MFN 06-218

Docket No. 52-010

**Subject: Response to Portion of NRC Request for Additional Information  
Letter No. 35 Related to ESBWR Design Certification Application –  
Solid Waste Management System – RAI Numbers 11.4-1 through  
11.4-11**

**RAI Numbers 11.4-1 through 11.4-11**

Figure 11.4-1. Solid Waste Management System Process Diagram

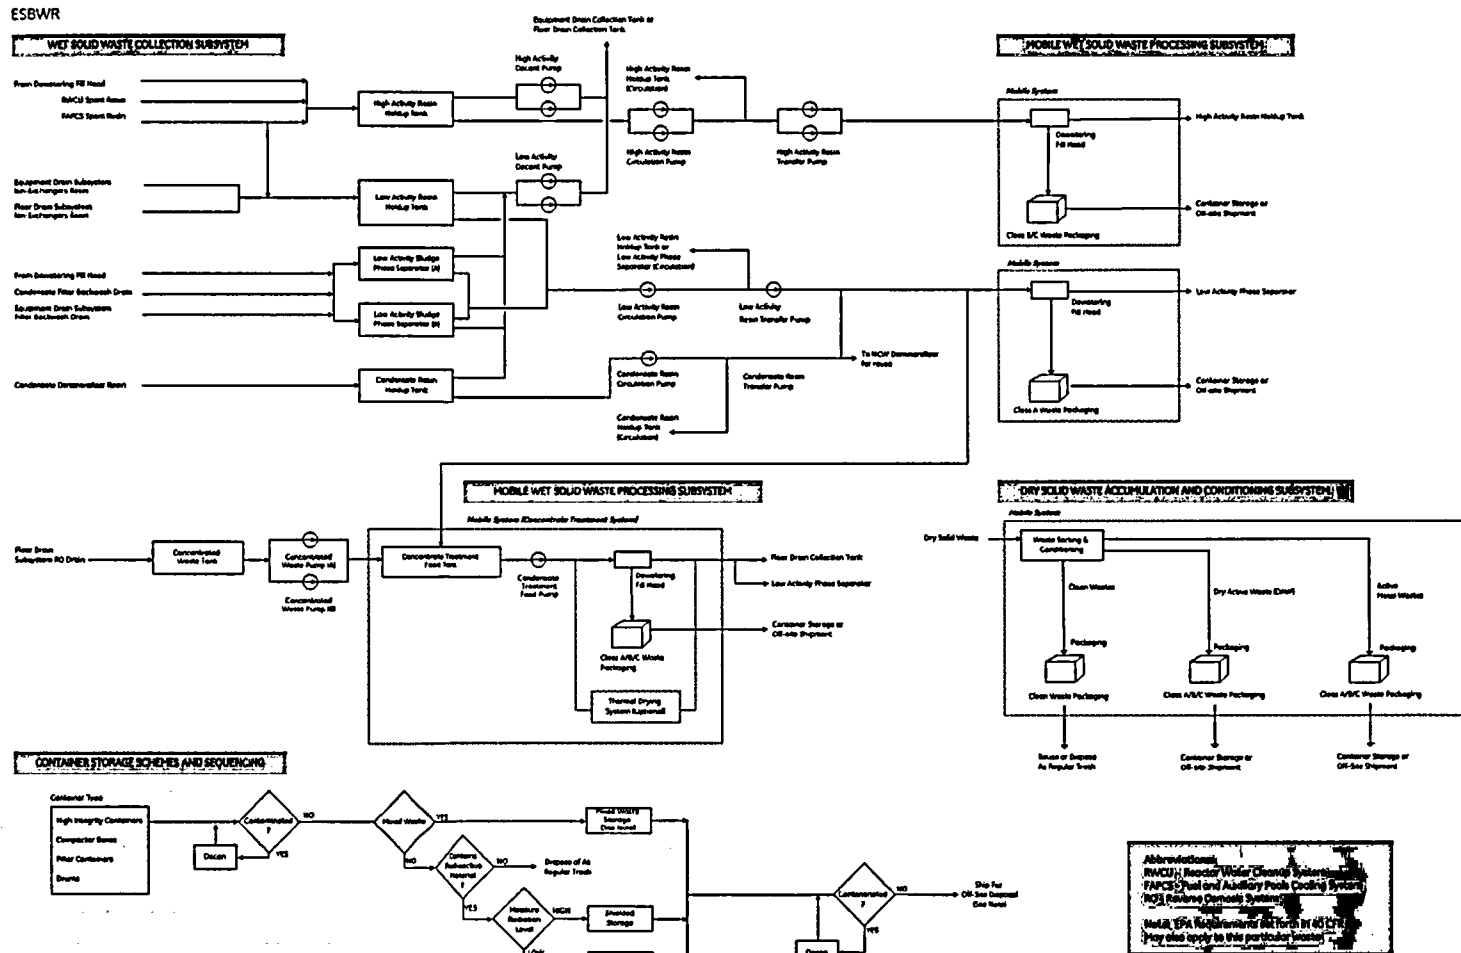
*DCD Tier 2, Section 11.4 states that the four subsystems of the solid waste management system (SWMS) are depicted on Fig. 11.4-1. A review of Figure 11.4-1 indicates that the container storage subsystem is not shown in this figure. Update DCD text and figure accordingly.*

Figure 11.4-1 and Section 11.4 have been revised to include the container storage subsystem. Attached to this RAI is Draft DCD Section 11.4, Rev. 02, including Figure 11.4-1, Rev. 02, for your review and use.
